TO HOLDERS OF 38T MICROPHONE MANUAL

REVISION NO. 4 DATED OCTOBER 1988

MODEL 38T MICROPHONE

**TELEX PART NUMBER 63999-000
THROUGH
TELEX PART NUMBER 63999-006**

MICROPHONE EXPLODED VIEW
Figure 3

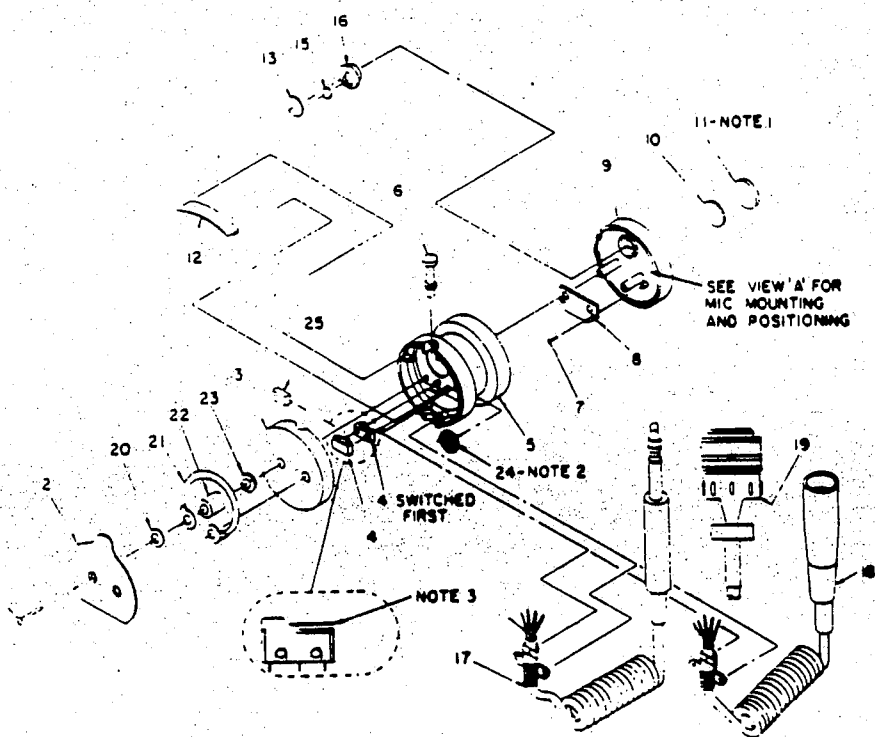
<u>Chapter/Section and Page No.</u>	<u>Description of Change</u>
All Pages	Non-technical style/format changes.
Title	Updated
Record of Revisions Page i	Revised to reflect this revision
List of Effective Pages Page ii	Revised to reflect this revision.
Contents Page iii	Revised to reflect this revision.
Description and Operation Pages 1 & 2	Switch specification: Changed "Push-to-talk sequential switching." to "Push-to-talk sequential switching (microphone part numbers 63999-001, -003, -004 and -005). Single switching (microphone part numbers 63999-000, -002 and -006)." Deleted "The push-to-talk switch is sequentially operated." from Operating Procedures.
Disassembly/Reassembly Page 3	Revised exploded view to reflect changes to microphone element and associated parts. Reference Service Bulletin AC-Mic-003 dated October 1988. Added notes to exploded view. Deleted note "Reassembly is the reversal of above procedures."

PART NUMBERS 63999-000, -002, -006
Figure 4

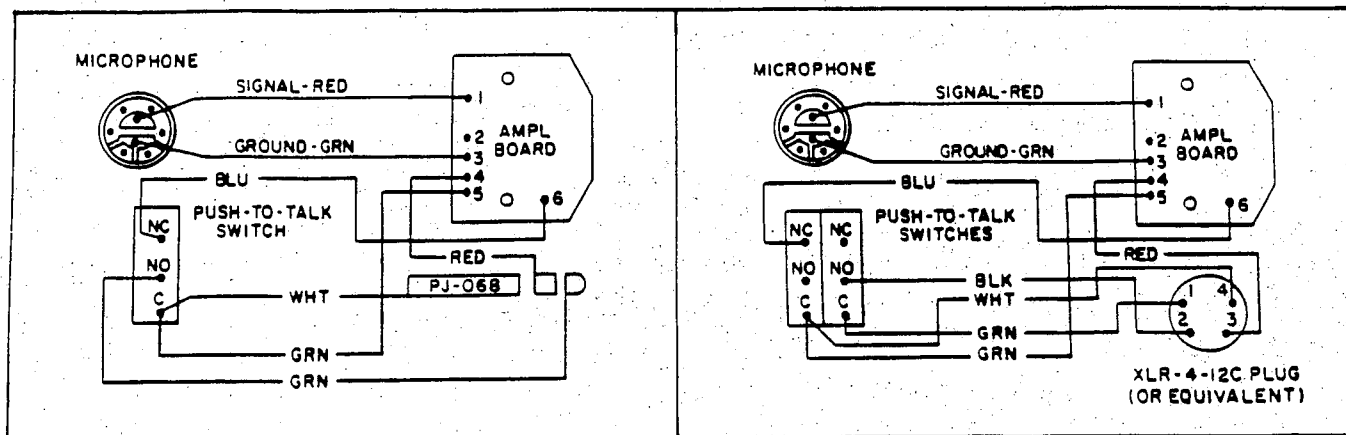
Deleted contents of page 5. Changed wiring diagrams on page 5a to reflect microphone element change, and moved contents of page 5a to page 5. Deleted page 5a. Reference Service Bulletin AC-Mic-003 dated October 1988.

TEST CIRCUIT
Figure 7

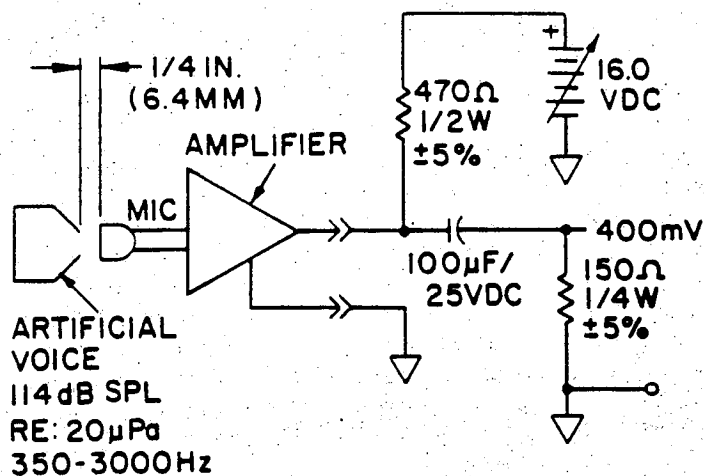
Modified test circuit for use with changed microphone element: 100 microfarad capacitor was 25 microfarad. Reference Service Bulletin AC-Mic-003 dated October 1988.
